SUBJECT: SALEM NUCLEAR GENERATING STATION, UNIT NO. 1 (TAC NO. M95383)

The Commission has issued the enclosed Amendment No. 201 to Facility Operating License No. DPR-70 for the Salem Nuclear Generating Station, Unit No. 1. This amendment consists of changes to the Technical Specifications (TSs) in response to your application dated May 10, 1996, as supplemented March 19 and August 29, 1997.

AMENDMENT TO FACILITY OPERATING LICENSE

Amendment No. 201  
License No. DPR-70

FIGURE 2.1-1  
 REACTOR CORE SAFETY LIMIT - FOUR LOOPS IN OPERATION

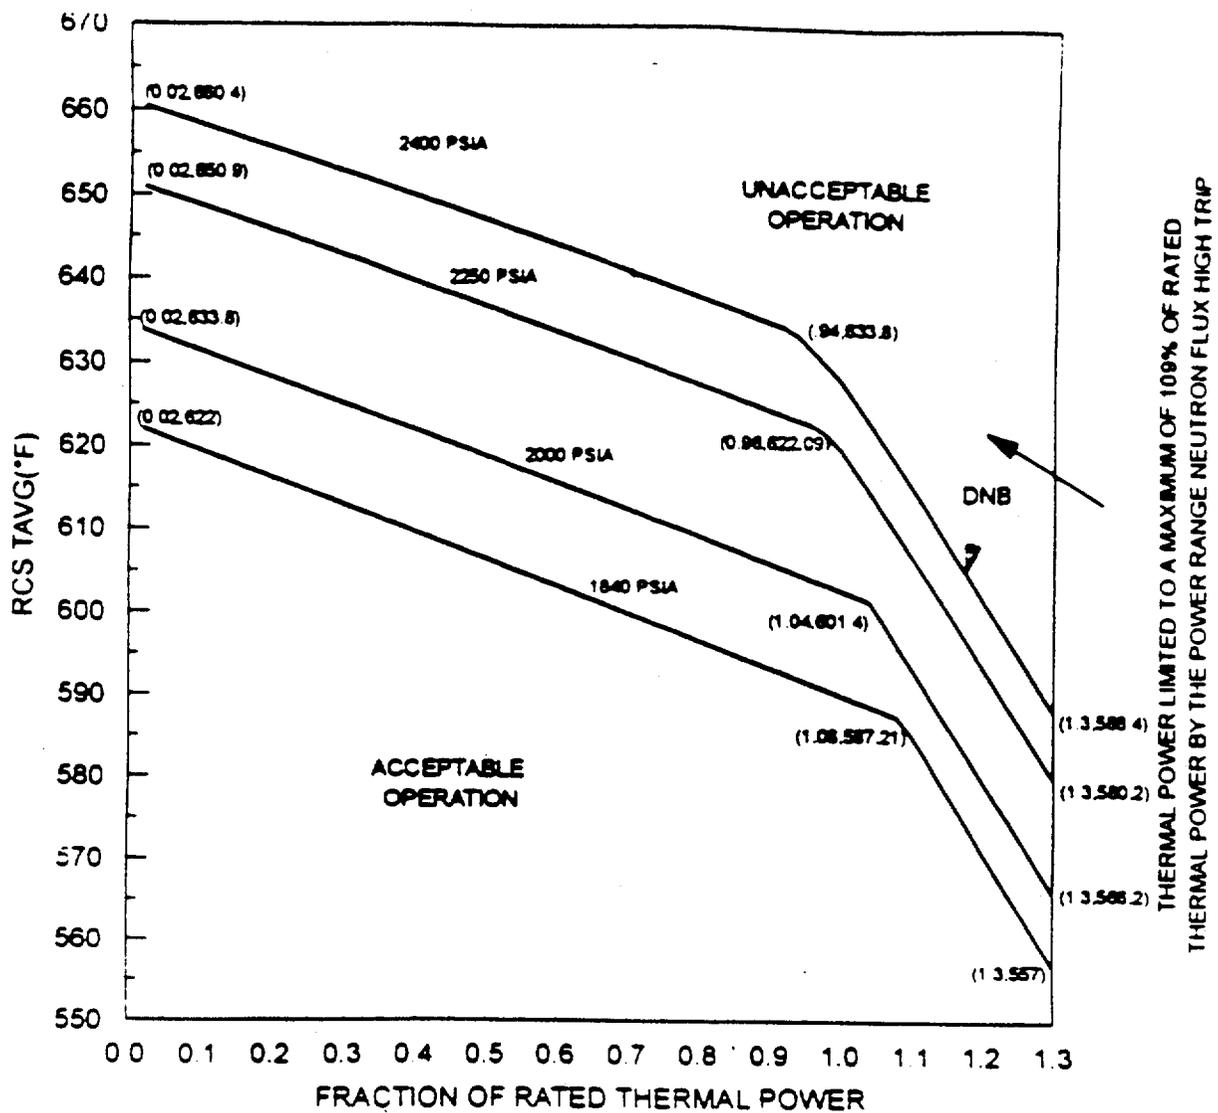
2.1.1 The combination of THERMAL POWER, pressurizer pressure, and the highest operating loop coolant temperature ( $T_{avg}$ ) shall not exceed the limits shown in Figure 2.1-1 for 4 loop operation.

The curves of Figure 2.1-1 shows the loci of points of THERMAL POWER, Reactor Coolant System pressure and average temperature for which the minimum DNBR is no less than the design DNBR value, or the average enthalpy at the vessel exit is equal to the enthalpy of saturated liquid.
